UNITED STATES PATENT AND TRADEMARK OFFICE

APPLICATION NO.	FILING DATE	FIRST NAMED INVENTOR	ATTORNEY DOCKET NO.	CONFIRMATION NO.
10/090,146	03/05/2002	Chikaho Ikeda	112116	5449
25944	7590	08/10/2005	EXAMINER	
OLIFF & BERRIDGE, PLC P.O. BOX 19928 ALEXANDRIA, VA 22320			FLORES RUIZ, DELMA R	
			ART UNIT	PAPER NUMBER
			2828

Office Action Summary

DETAILED ACTION

Fig. 2

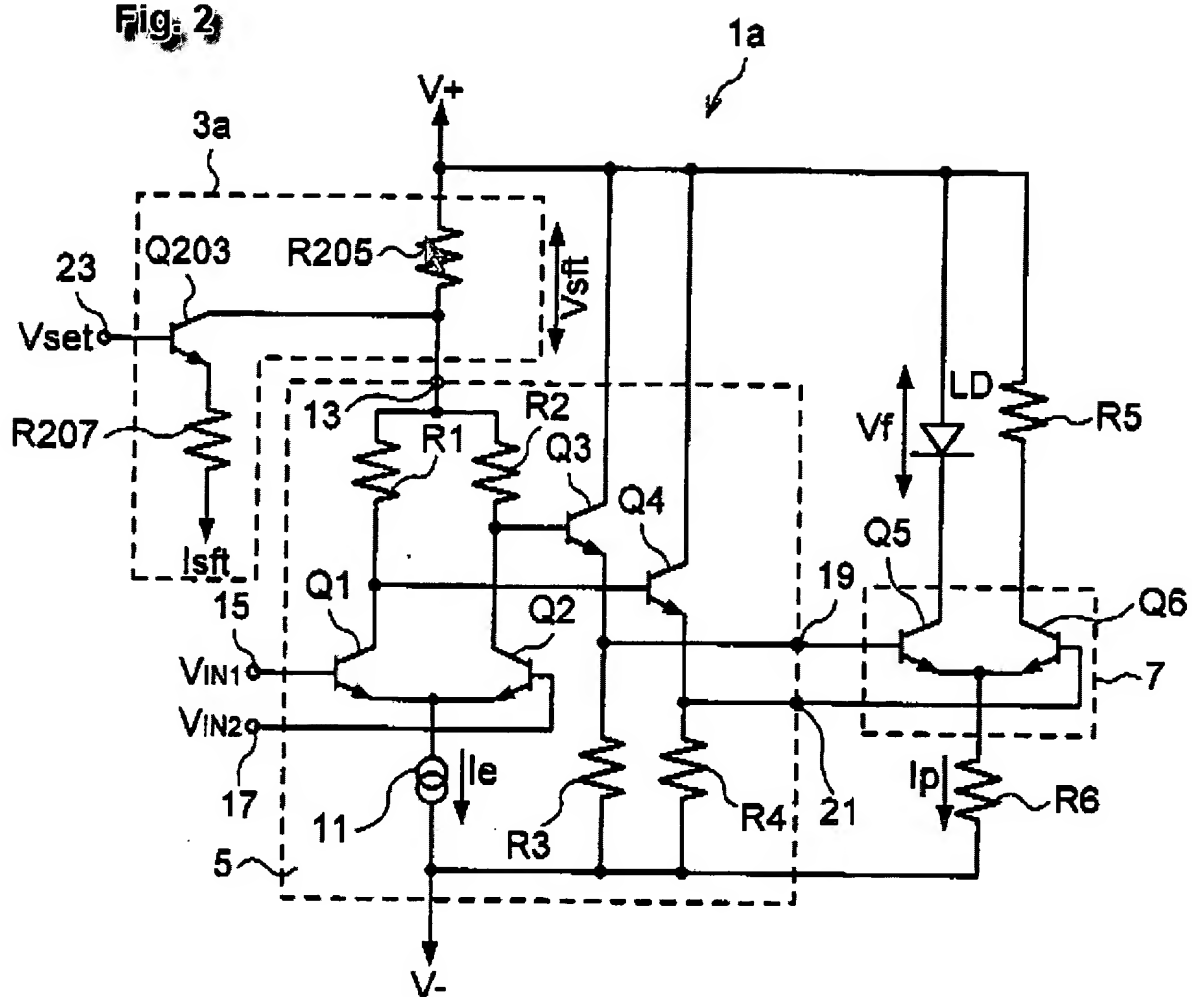
Claim 14 is rejected under 35 U.S.C. 102(e) as being anticipated by Kikuchi (6,510,168).

Regarding claim 14 Kikuchi discloses an apparatus for driving a light emitting element in response to input data, the light emitting element emitting light by causing a direct current to flow thereto, (see Fig. 2, Character 1a) the apparatus comprising: a voltage driving section (see Fig. 2, Characters V+ and V-) for driving the light emitting element (see Fig. 1, Character LD) with voltage; a current driving (see Fig. 2, Character Ip) section for driving the light emitting element with a current; and a switching section (see Fig 2. Character 7) for changing voltage drive by the voltage driving section and current drive by the current driving section based on the input data (see Fig. 2, Abstract, Column 1, Lines 52 – 55, Column 4, Lines 1 – 57).
